**OFFICE OF NEW REACTORS**  
**SUMMARY FEEDBACK ON FOUR KEY LICENSING ISSUES**  
**NEXT GENERATION NUCLEAR PLANT**  
**PROJECT 0748**

**INTRODUCTION**

**Figure 1.** NGNP Frequency-Consequence curve proposed by DOE/INL (ML12262A090)

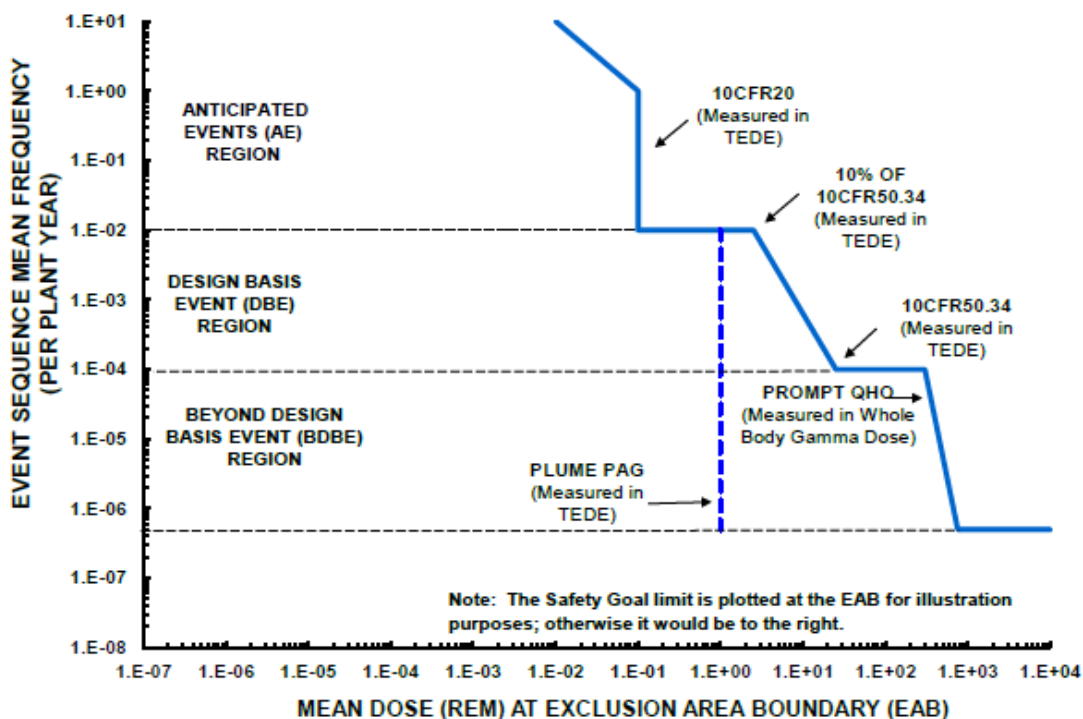
The NRC staff concludes that the proposed approach to placing top level regulatory criteria (TLRC) on a frequency-consequence (F-C) curve is reasonable. Figure 1, a copy of DOE/INL's proposed F-C curve, identifies the regulatory bases for the respective TLRC and displays the TLRC-based dose limits as a function of event sequence mean frequency over the proposed event category regions.

The proposed FC-curve's event category regions and their respective TLRC bases are summarized as follows:

- The TLRC for the AE region would be based on limiting the annual dose to an individual member of the public to 100 millirem total effective dose equivalent (TEDE) as required in 10 CFR Part 20, "Standards for Protection against Radiation." DOE/INL proposes that AE source terms should be mechanistically modeled and that dose consequences should be realistically calculated at the exclusion area boundary (EAB).

- The TLRC for the DBE region would be based on an event-based public dose criterion of 25 rem TEDE as required in 10 CFR 50.34, "Contents of Applications; Technical Information."<sup>7</sup> DOE/INL proposes that DBE source terms should be mechanistically modeled and that dose consequences should be conservatively calculated at the EAB.

- The TLRC for the BDBE region would be based on cumulative public dose limits derived from the quantitative health objectives (QHOs) of the NRC safety goals, whereby the QHO for prompt fatality is the most limiting. DOE/INL proposes that BDBE source terms should be mechanistically modeled and that offsite dose consequences should be realistically calculated.
